2. AMENDMENT/MODIFICATION NUMBER  
00043. EFFECTIVE DATE  
09/20/2023

## **Minor-Construct New Entryway Bldg. 17 Lebanon, PA**

**SOLICITATION # 36C77623R0122**  
**PROJECT NAME: Minor Construct New Entry-Lebanon, PA**  
**TECHNICAL QUESTIONS AND VA RESPONSE TRACKING SHEET**

1 GROUND FLOOR POWER PLAN  
E301 1/8" = 1'-0"

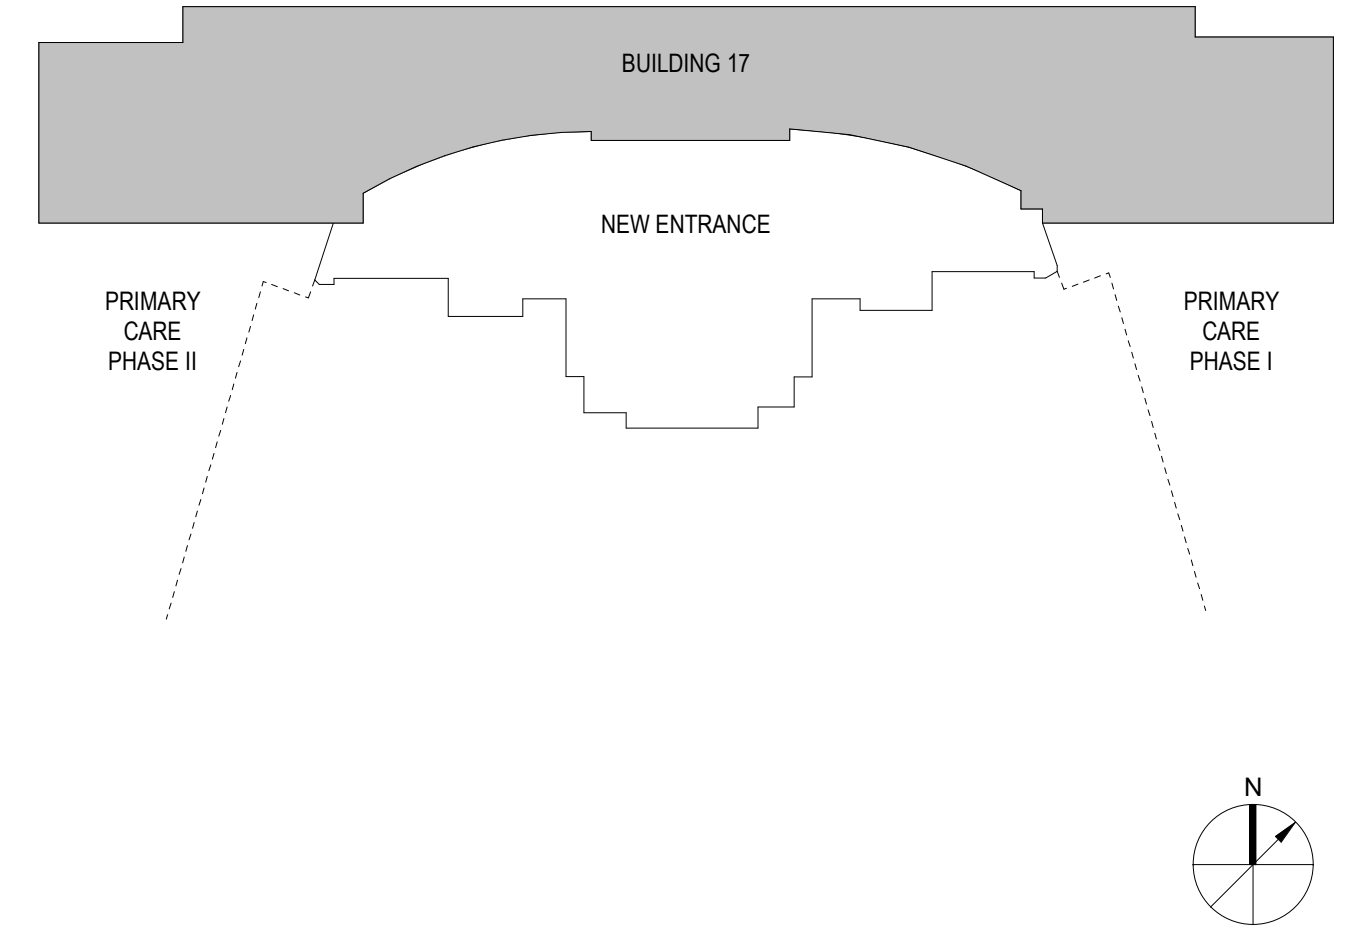
ITEM NO.	DATE QUESTION RECEIVED	DATE QUESTION ANSWERED	QUESTION	GOVERNMENT RESPONSE
34.	07/27/2023	09/20/2023	Drawing E301 – Behind the main reception desk there is a symbol with a P next to it. Nothing is shown on the legend for this symbol. Is this for a panic button? If so, is Siemens to tie it into the hospital wide panic alert system?	<i>This a panic button. A specification will be issued in the addendum.</i>

35.	07/27/2023	09/20/2023	Drawing E301 – This print shows the new temporary entrance. Access control is shown on the door. Does the LVMC require any CCTV cameras to cover the outside / inside of the temporary door?	Please provide a camera observing the new temporary entrance to include the ramp and stairs areas.

36.	07/27/2023	09/20/2023	Drawing A601 door schedule – Doors 101A-B-C-D are automatic sliding doors. Drawing E301 shows electric strikes and door contacts. Sliding doors don't use electric strikes or door contacts. Please advise as to a solution. Recommend automatic door contractor to provide locking device in door with door position switches which security contractor can tie into.	Delete card reader, electric strikes, and door contacts on E301. Door hardware spec is correct.

37.	07/27/2023	09/20/2023	Drawing A601 door schedule – Temporary doors T101A are automatic swing doors. Drawing E301 shows electric strikes and door contacts. Automatic swing doors don't use electric strikes or door contacts. Please advise as to a solution. Recommend automatic door contractor to provide locking device in door with door position switches which security contractor can tie into.	Delete card reader, electric strikes, and door contacts on E301. Door hardware spec is correct.

43.	07/27/2023	09/20/2023	Drawing E301 shows SP-1 & SP-2 fed from a duplex receptacle, however on drawing E401 mechanical equipment wiring schedule it shows a 30amp manual motor switch. Please clarify if the 30amp manual motor switch is required.	Delete motor rated switch for sump pumps.
